Southern Nuclear Operating Company  
Vogtle Electric Generating Plant Units 3 and 4  
Request for License Amendment:  
PMS Logic Changes for Source Range Flux Doubling (LAR-16-006)

**PMS Logic Changes for Source Range Flux Doubling**

**(LAR-16-006)**

**Proposed Changes to the Licensing Basis Documents  
(LAR-16-006)**

**Tier 2 UFSAR Figure 7.2-1 (Sheet 3 of 21) Functional Diagram Nuclear Startup Protection, Figure update**

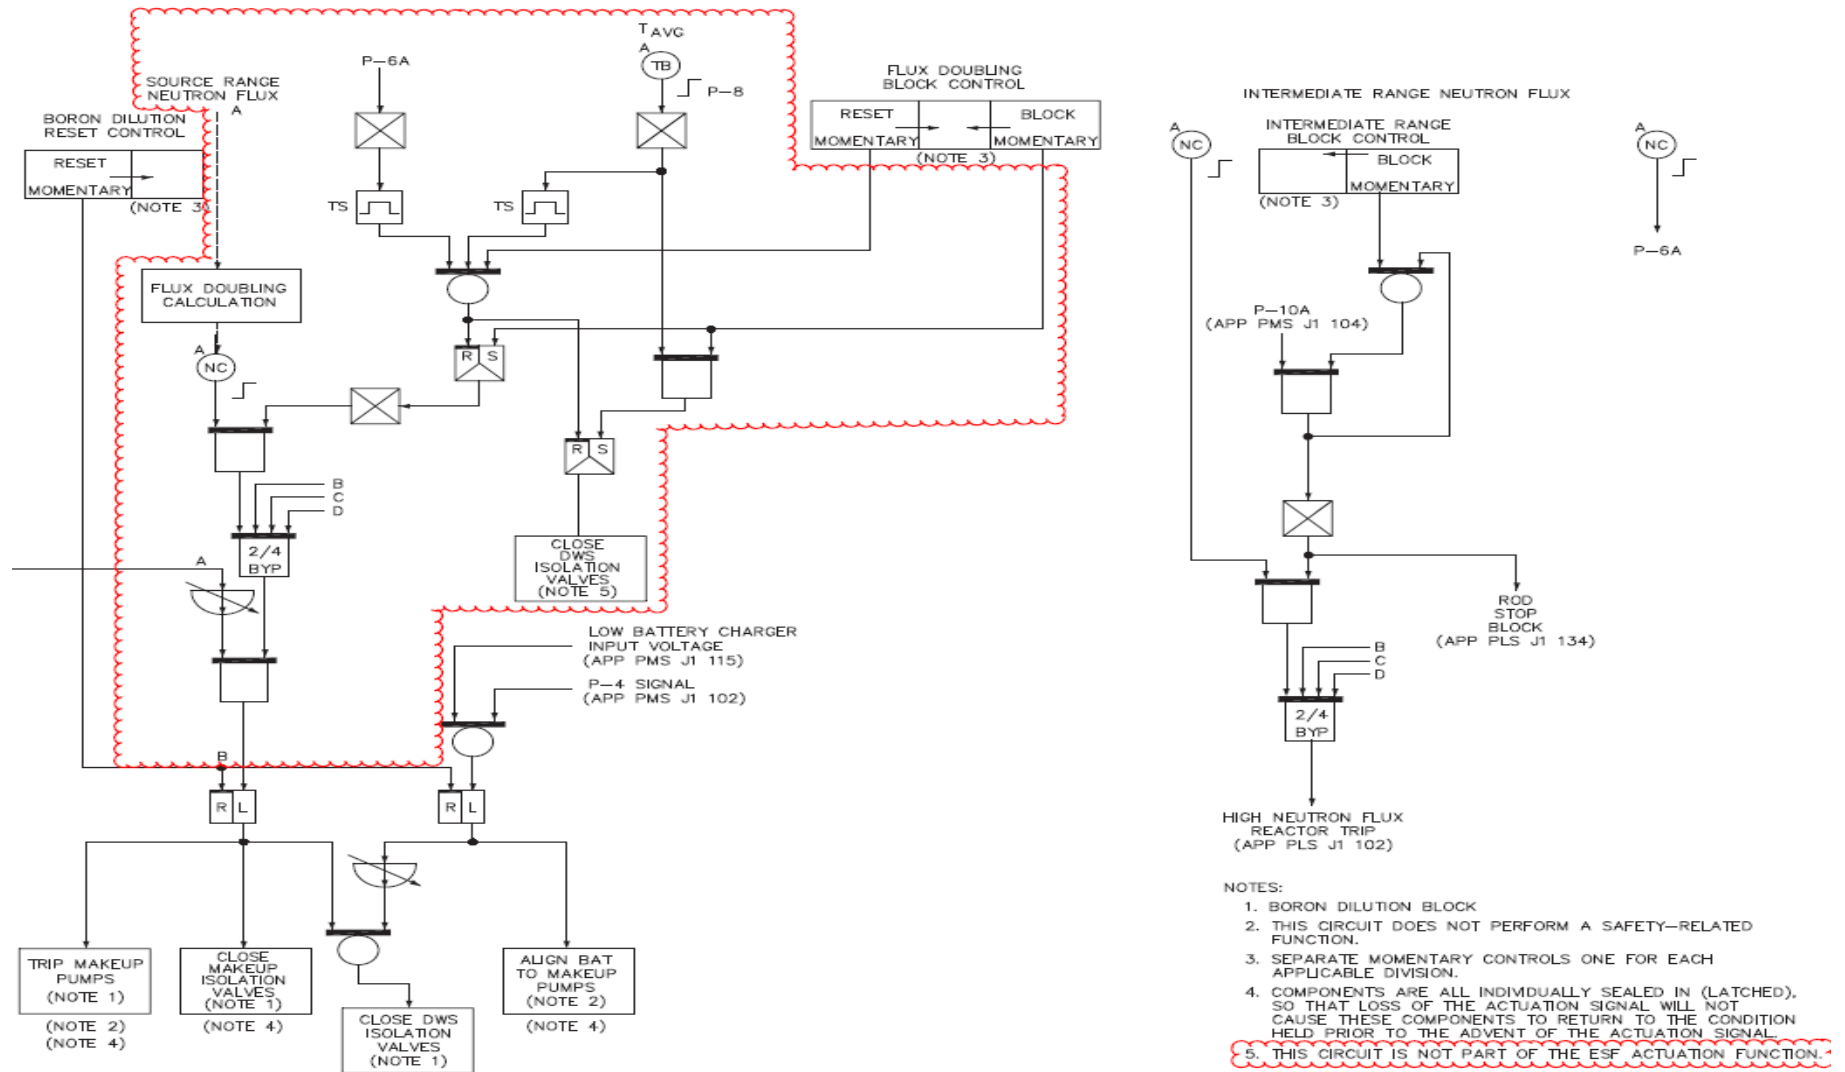
- Figure 7.2-1 (Sheet 3)

The PMS logic figure is changed to reflect the design changes described above, as follows:

- A close signal is sent to the CVS DWS isolation valves if the P-8 permissive is not set (i.e.,  $RCS T_{avg}$  is below the P-8 setpoint) and the operator blocks the flux doubling portion of the boron dilution block function.

- A circuit is added to automatically reinstate the flux doubling protection when plant conditions decrease to less than the P-8 setpoint. The circuit remains unchanged in the fact that it reinstates the flux doubling protection when plant conditions decrease to less than the P-6 setpoint.

- Since the new function block to “Close DWS Isolation Valves” is not required to mitigate any design basis event, a note is added to state that it is not an Engineered Safety Feature (ESF) actuation function. The existing function block to “Close DWS Isolation Valves” remains an ESF actuation function because it is required to mitigate a possible design basis event (i.e., boron dilution). Both functional blocks actuate closure of CVS valves 136A (PMS Division A) and 136B (PMS Division C). The physical components and process to close the CVS DWS isolation valves downstream of PMS are the same for each function block.
